ADDENDUM NO. 2

CLARIFICATION NO. 2

LANDSCOPE (MAURITIUS) LTD
INFRASTRUCTURE WORKS FOR EDUCATION AND HEALTH HUB AT COTE D'OR
REF No.: LM/CD/OC23/35

23125-TD-3TP413

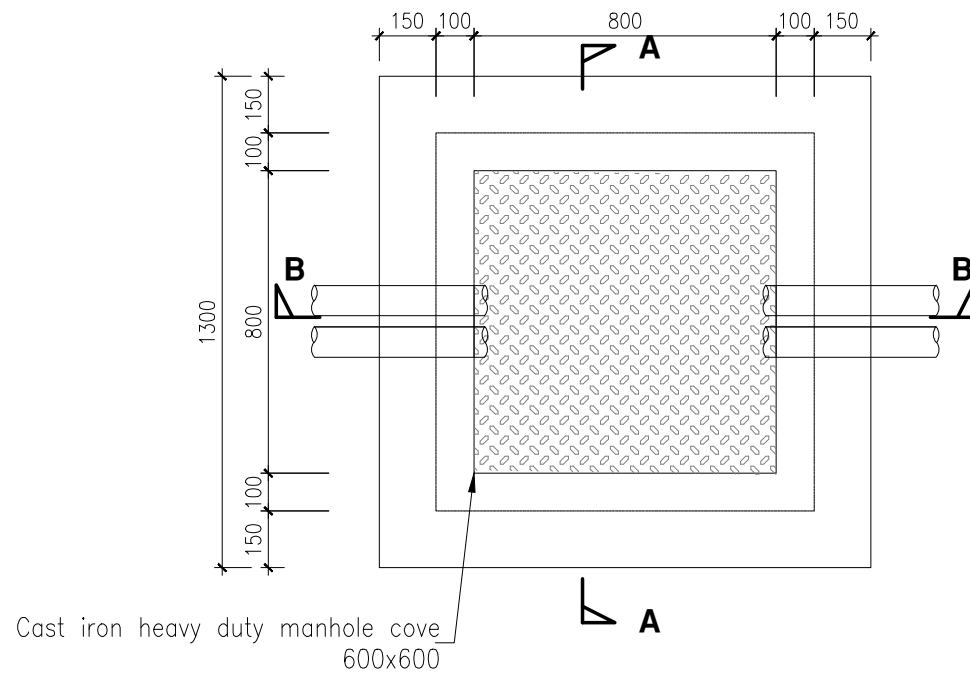
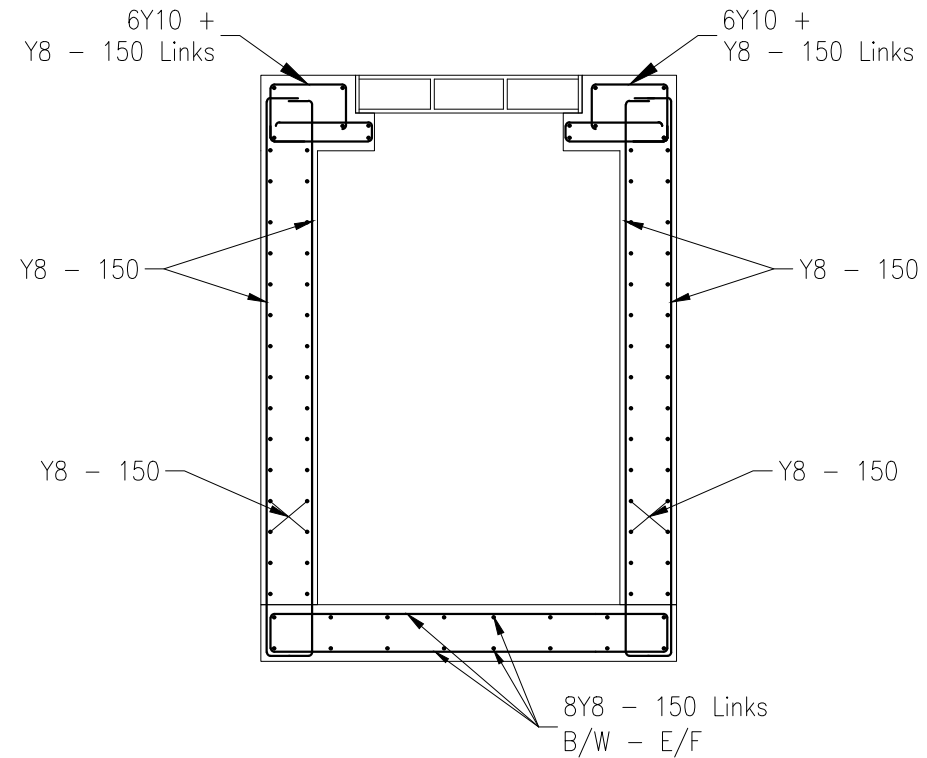
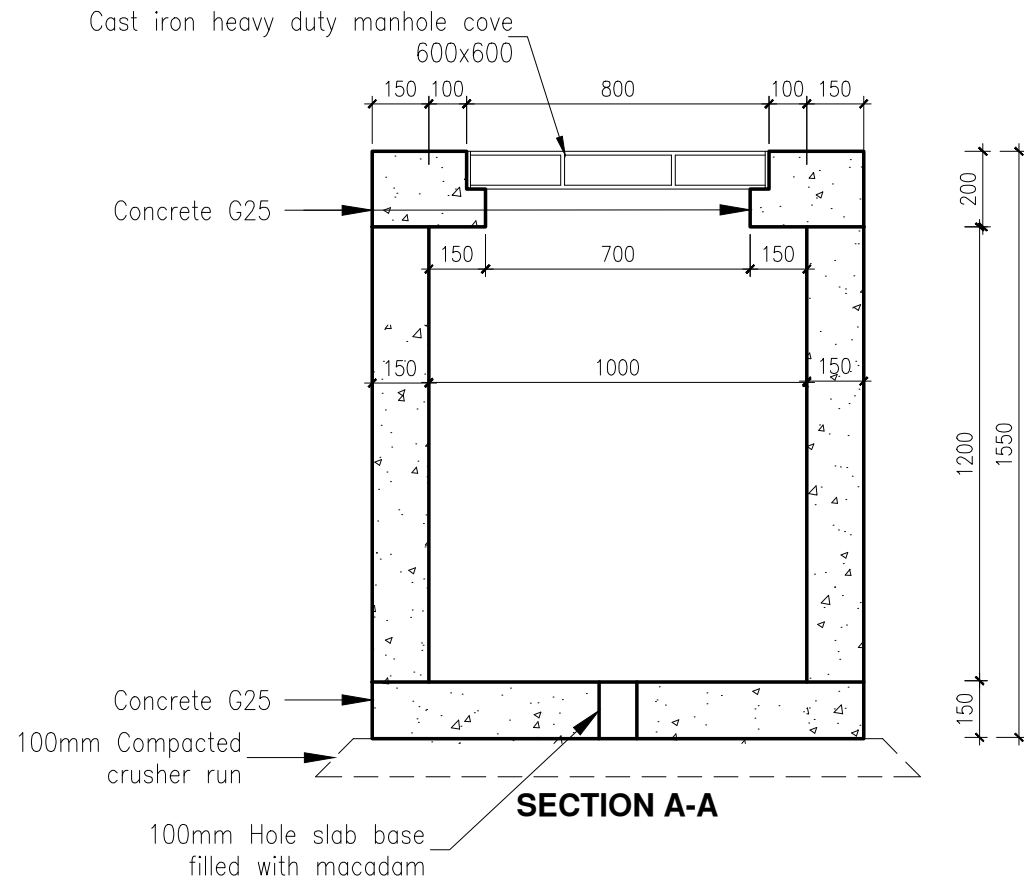
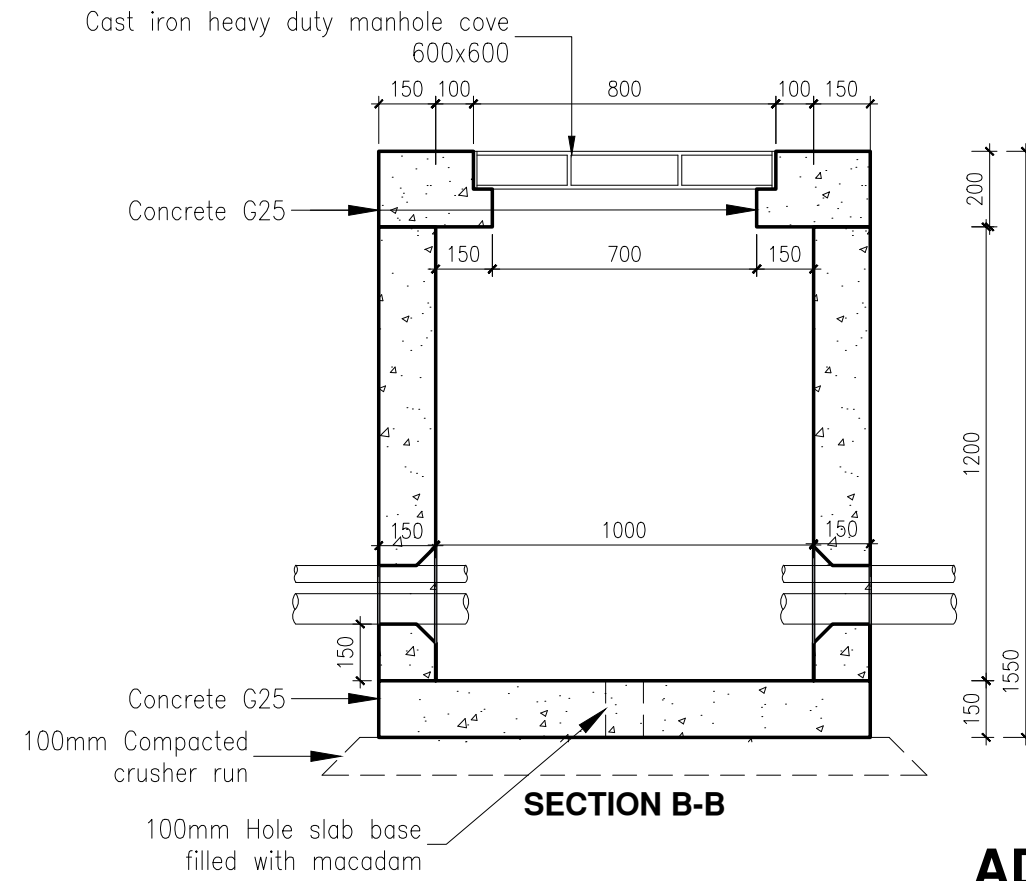
SN	ORIGINAL QUERIES BY BIDDERS	REPLY FROM EMPLOYER
32.	Lot 2 Bill Item 905D Kindly provide detailed drawing with dimensions.	It is hereby brought to the attention of the bidders that a new drawing labelled 23125-TD-3TP413 marked with “Addendum No. 2” forms part of Volume 3 of 4 the bidding document as attached in Annex O . Changes to the description of item 905D has been done to the BOQ and it is hereby brought to the attention of the bidders that page 251 of Volume 1 of 4 has been replaced by Page 251 with labelling “Addendum No. 2”as attached in Annex P .

Drawing title:
TYPICAL DETAILS OF CATCH PIT TYPE 3 - (Height 1.20m)

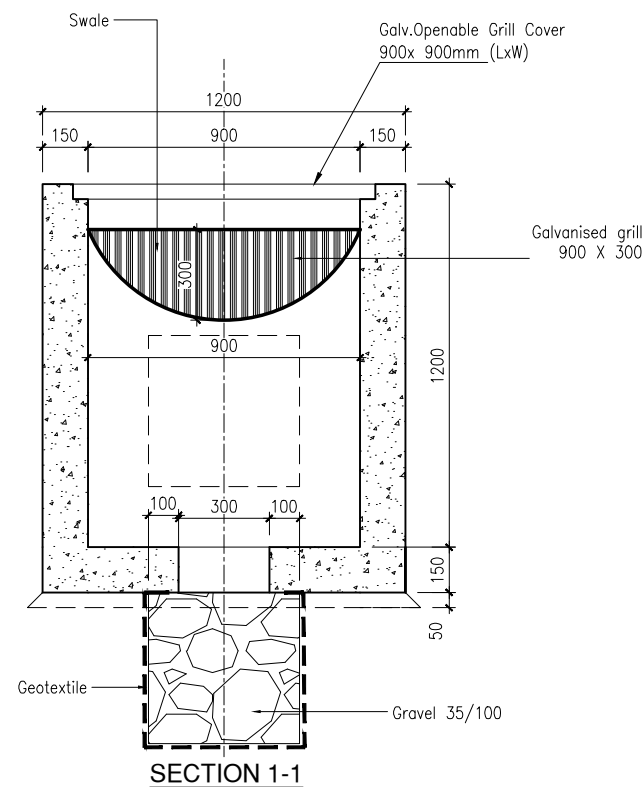
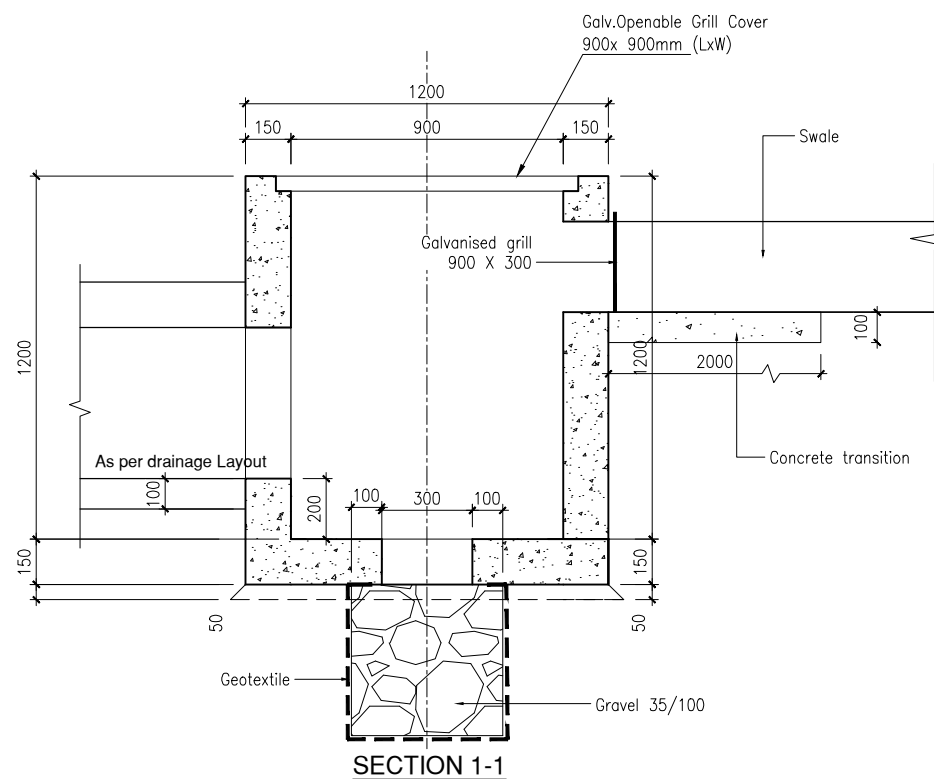
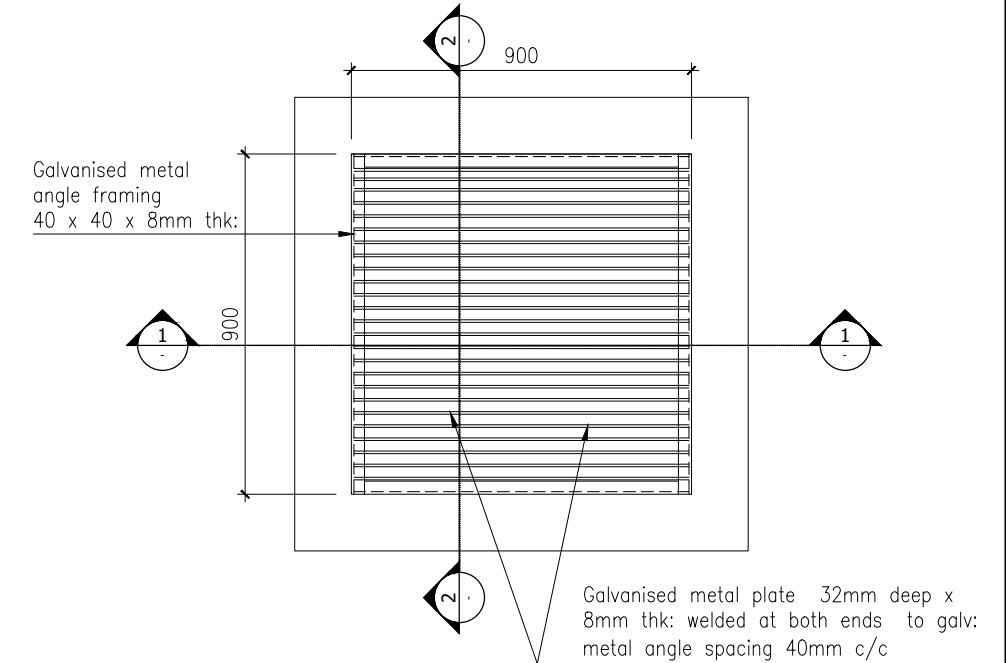
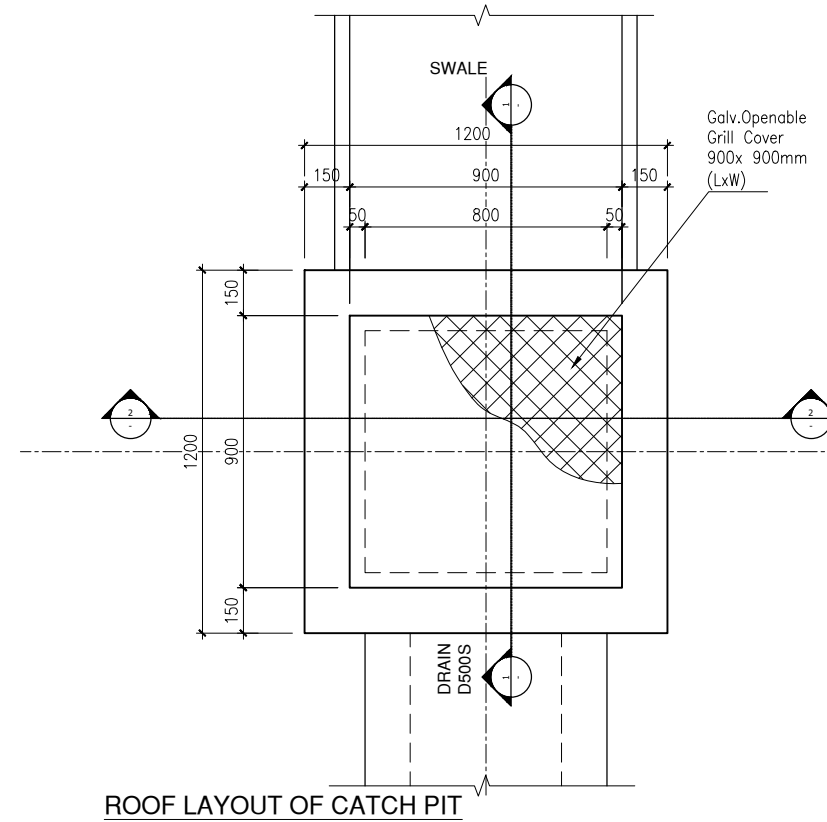
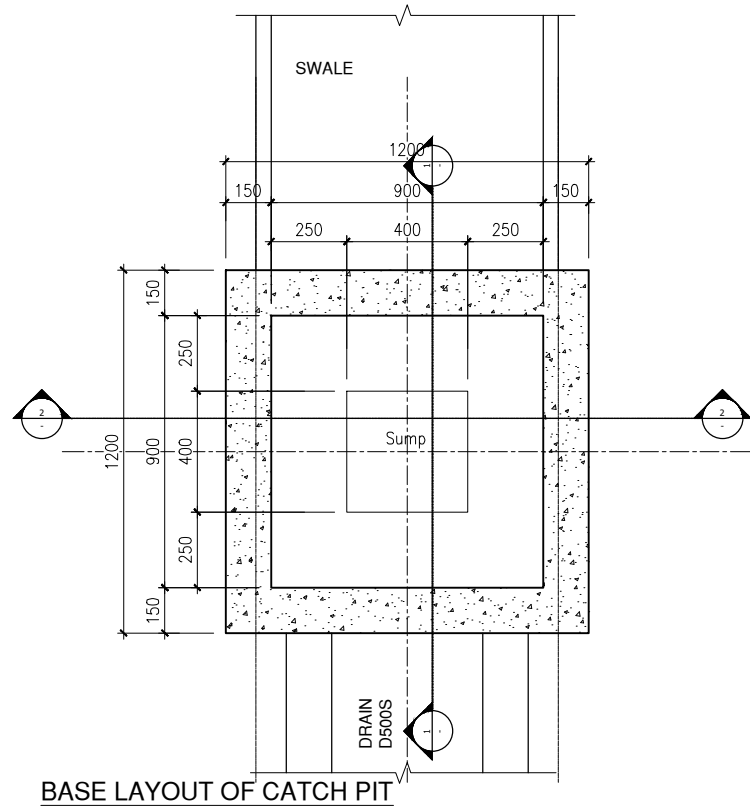
36.	Drawings for catchpit type 3 – item 604C	It is hereby brought to the attention of the bidders that a new drawing labelled 23125-TD-3TP218 marked with “Addendum no. 2” forms part of Volume 3 of 4 the bidding document as attached in Annex R .
